Woollahra
Municipal
Council

COUNCIL ASSESSMENT REPORT

SYDNEY EASTERN CITY PLANNING PANEL

PANEL REFERENCE & DA NUMBER	PPSSEC-363 – DA 557/2024/1
PROPOSAL	Demolition of existing structures and construction of a new 4 storey building for health services facility with basement car parking
ADDRESS	4-8 Manning Road, Double Bay Legally known as SP43881 (4 Manning Road) and Lots 2 & 3 DP 829784 (6-8 Manning Road)
APPLICANT	Christopher Adams
OWNER	Allan Geoffrey Simpson and Beverley Anne Simpson
DA LODGEMENT DATE	15 January 2025
APPLICATION TYPE	Integrated Development Application
REGIONALLY SIGNIFICANT CRITERIA	Section 2.19(1) and Clause 5 (b) of Schedule 6 of <i>State Environmental Planning Policy (Planning Systems) 2021</i> declares the proposal regionally significant development given: The proposed development has an estimated development cost of more than \$5 million and is for the purpose of a health services facility.
CIV	\$13,756,883.21 (excluding GST)
CLAUSE 4.6 REQUESTS	Woollahra Local Environmental Plan 2014 - Part 4, Clause 4.3: Height of Buildings & E1 Local Centre Zone

Proposed	Control	Complies
Maximum Building Height	17.7m as measured to the top of rooftop screening	14.7m	No

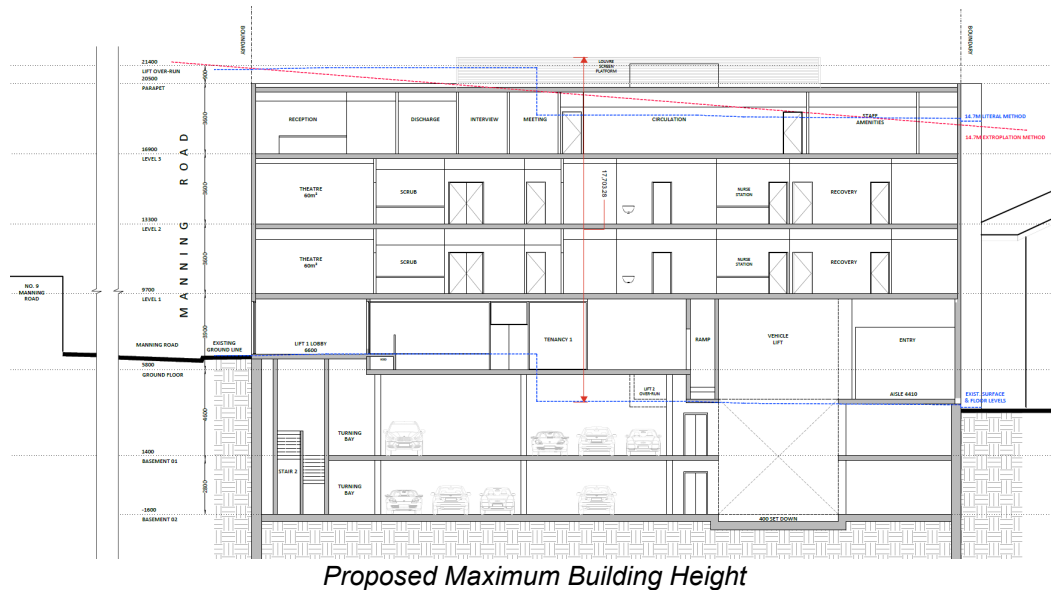
Clause 4.3(2) limits development to a maximum height of 14.7m.

Part D5.5.11: Control drawing 7 illustrating heights & setbacks applicable to each level of the Site

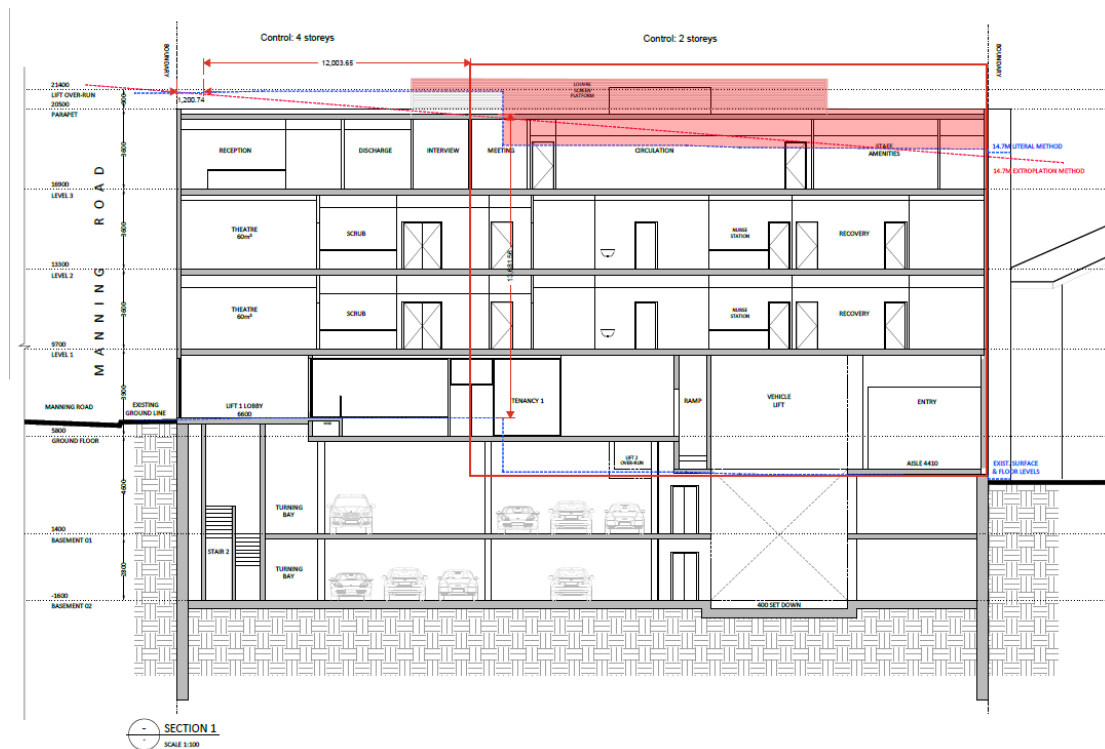
As illustrated below, the proposed height breach is limited to a portion of Level 3 to the rear and rooftop services/screening and is acceptable for reasons outline at Section 14.4.1 of this report.

- An articulation zone at the site frontages of 1.2 metres deep upon which only 50% may be built upon at Levels 2 & 3 along Manning Road and for a length of 15.6m along Kiaora Lane, as measured from the Manning Road frontage.

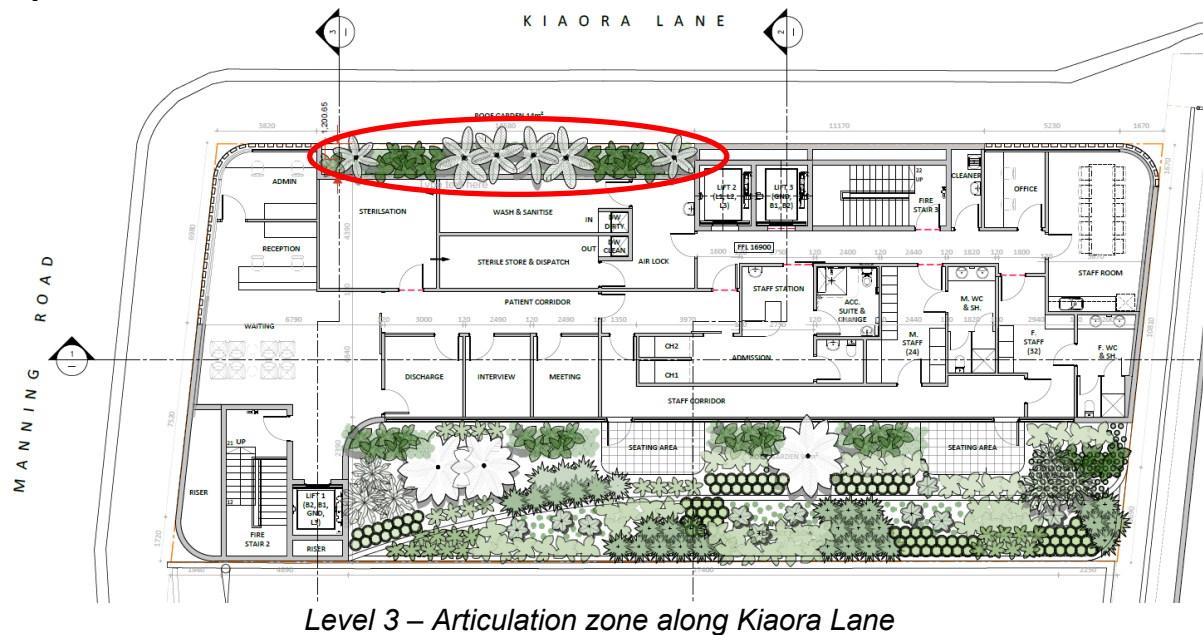
An articulation zone has not been provided along either frontage at Level 2. Whilst the Proposal does not strictly compliant with the abovementioned control, as illustrated below, a 1.2m

articulation zone is provided at Level 3 along Kiaora Lane, enabling the provision of a planter. The introduction of this planter, coupled with the integration of textured and patterned brickwork, ground level glazing, curved walls and a 'wave-like' treatment at ground and third floor, provides an appropriate degree of articulation along each frontage, complying with Objective O2.

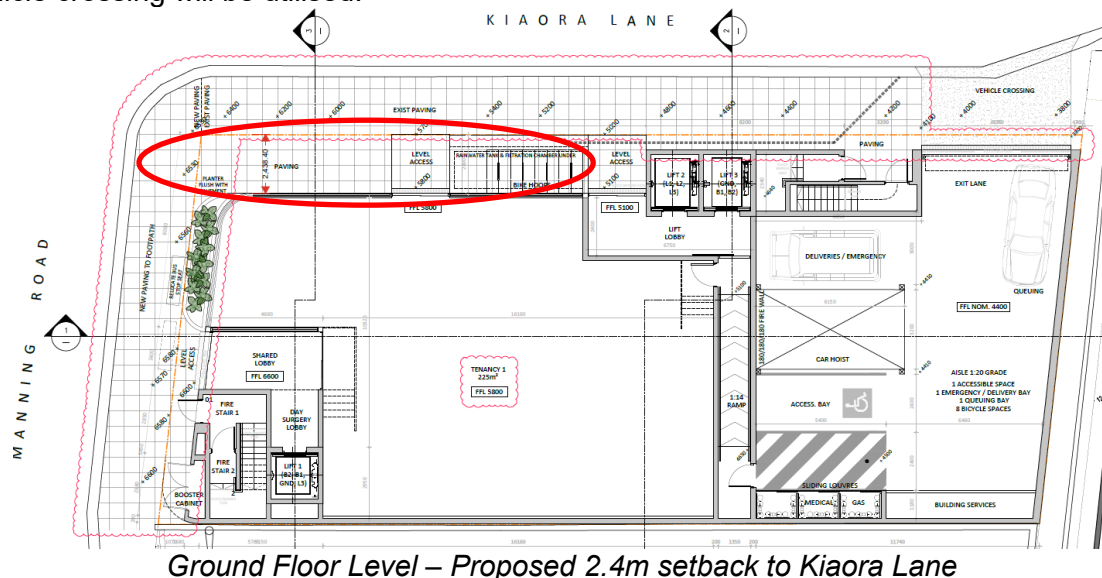
- A 2.4 metre setback applies to the laneway frontage at Ground Floor Level.

As illustrated below, the Proposal incorporates a 2.4m setback to Kiaora Lane, with reduced setbacks proposed to the lift core, fire stair and roller door to the basement. Proposed setbacks will improve pedestrian amenity, whilst facilitating the service role of the Lane. It is further noted that proposed setbacks represent an improvement upon existing conditions and an existing vehicle crossing will be utilised.

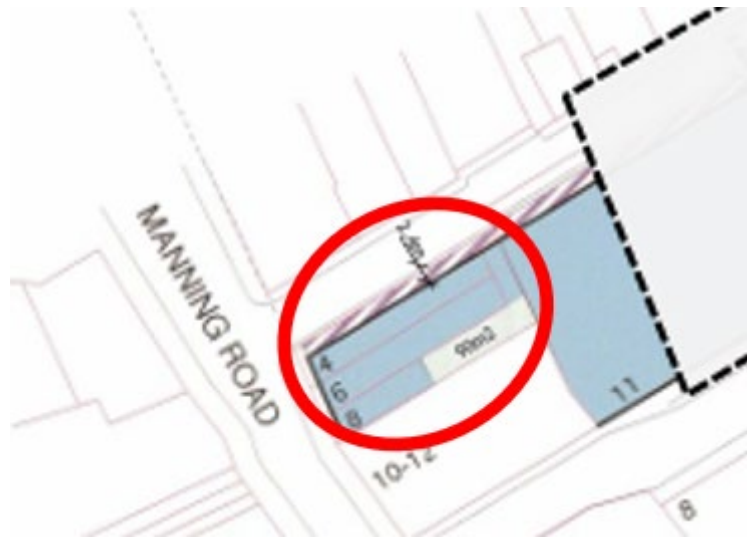
- As illustrated below, No. 8 Manning Road must include 90m² of landscaped area. Whilst 90m² of deep soil landscaping has not been proposed, 90m² of ground level landscaped area, a generous area of landscaping is proposed along the southern elevation in the form of raised planters. This is supported by Council considering it will soften the developments presentation to No.10-12 Manning Road, it will exceed the minimum 90m² requirement and the Proposal

represents a significant improvement upon existing conditions which features a very limited deep soil landscaping provision.

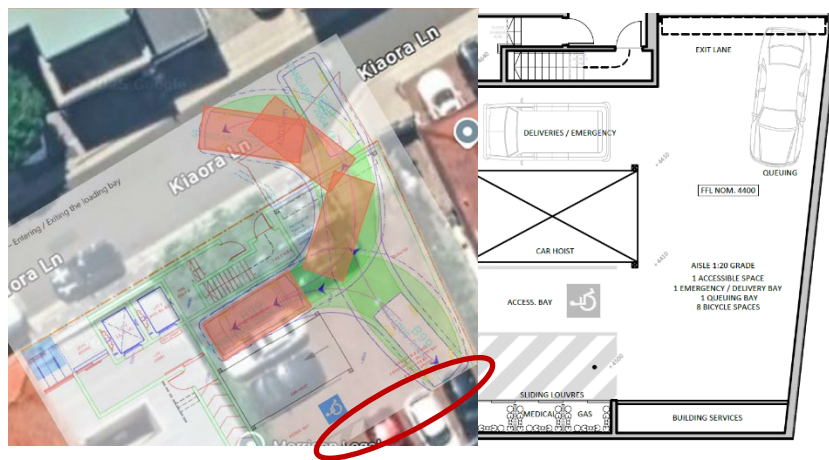
Parking and Traffic Generation for the proposal have been previously assessed, which identified insufficient parking provision for cars, bicycles and motorbikes. In response, the submitted Functional Design Statement and Traffic Letter indicated that 30% of day surgery centre staff will be driving to and from the site, and that ambulance attendance is not expected due to the nature of the proposed use.

The parking demand for the day surgery is calculated using First Principles approach, which accounts for a total of 41 staff and a maximum of 4 patients on a daily basis. The proposed provision of 4 spaces for the 4 patients, including 1 designed as an accessible space, is considered acceptable. Whilst the proposed 13 spaces for staff ($41 \times 30\% = 12.3$) achieves a numerical compliance with the requirements, it is unclear how the target of 30% of all staff driving to and from the site can be reached. It is therefore requested that a Green Travel Plan be developed to demonstrate the goals, targets and measures to facilitate alternative transport modes and reach the abovementioned goals and targets. Should the development be approved, this requirement will be conditioned.
